## ASSESSMENT REPORT

### University of New South Wales Biological Sciences Project SSD 6674 MOD 1

**Figure 3:** Approved and proposed development showing changes to building D26

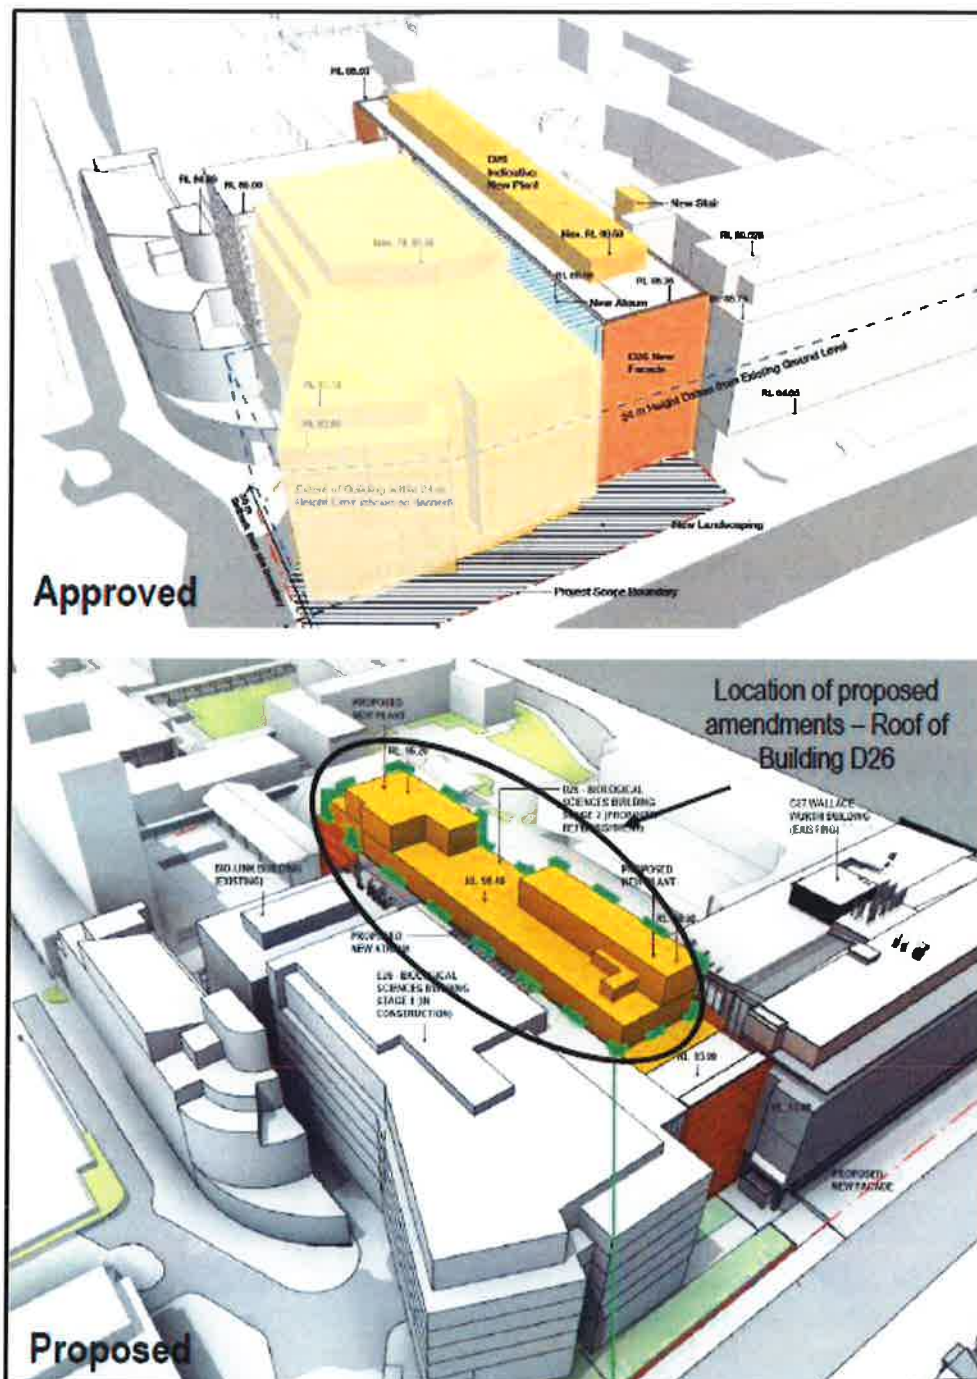
The modification is requested on the basis that it would provide improvements to the facility's appearance and functionality. It would also remove a requirement to pay monetary contributions for the upgrade of an intersection that is no longer required. The proposed changes are shown in **Figures 3 to 5**.

**Figure 7:** View of the proposed building from Botany Street as proposed (Note – additional plant levels not visible from this vantage point).

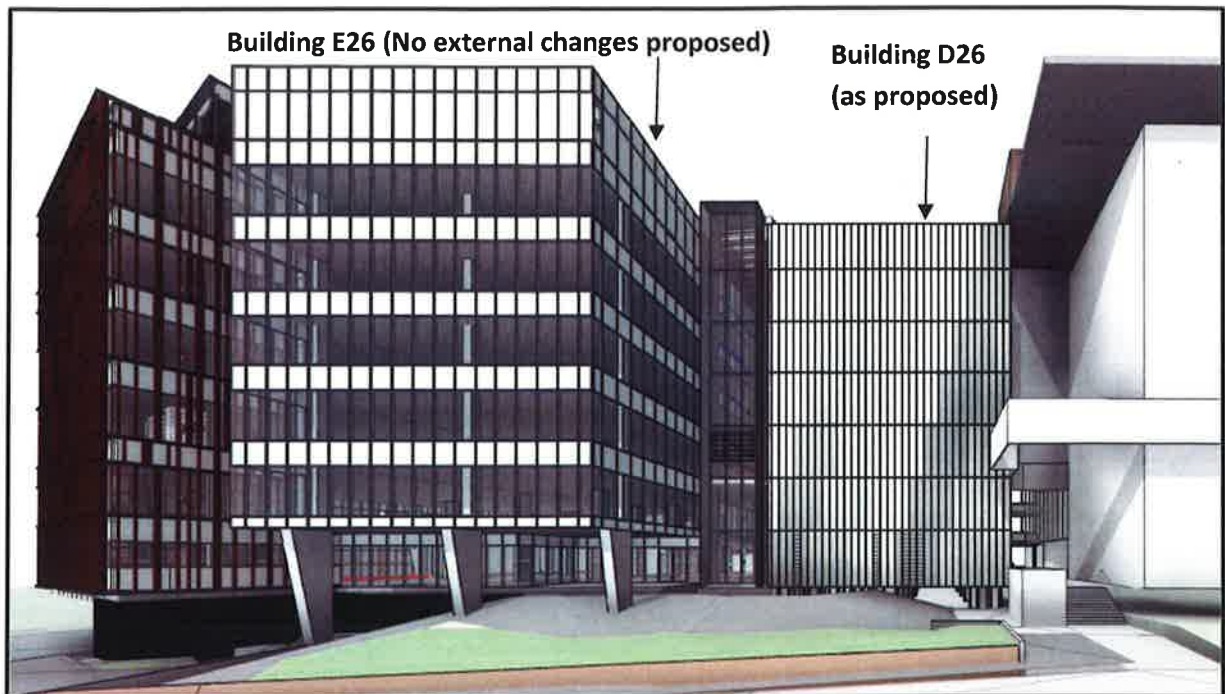
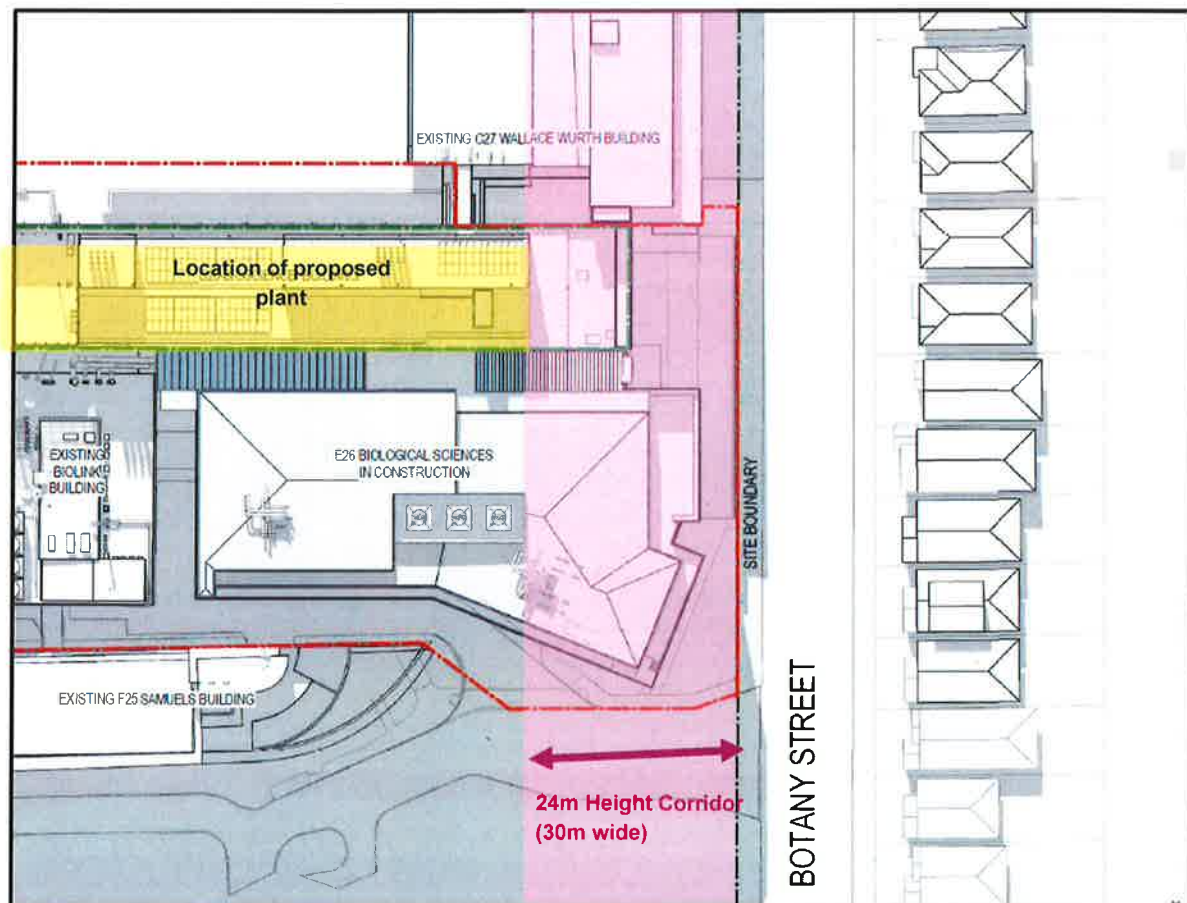
The proposal seeks approval to include an additional level of plant on Building D26. This would increase the height of the building by 5.8 metres (from 35 metres to 40.8 metres) as shown in **Figures 6 to 8**. The proposal also includes changes to the design of the facades. These changes have been considered in **Section 7.3**.

Council raised concern that the plant levels would be visually intrusive when viewed from the public domain and therefore an alternative design should be investigated.

The Department has carefully considered the visual impacts of the additional building height and concludes the modifications are appropriate, as:

- the rooftop plant has been designed to minimise its visual impacts, by setting the plant back from all edges of the building, and screening it with materials which are in keeping with the design of the building;
- the plant is set back 30 metres from the eastern façade, so it would not be highly visible from Botany Street (as seen in **Figure 6**) and would appropriately transition to the lower scale residential development to the east of the site;

- when viewed from vantage points outside the University, the plant would generally be obscured from view by the existing buildings on the site; and
- the increased height would not generate any adverse amenity impacts such as overshadowing, view loss or privacy impacts (refer to discussion in **Section 7.3** below).

The Department's assessment therefore concludes the proposed plant level is acceptable as it is consistent with the RLEP 2012 height controls and would not result in any unreasonable visual or amenity impacts.
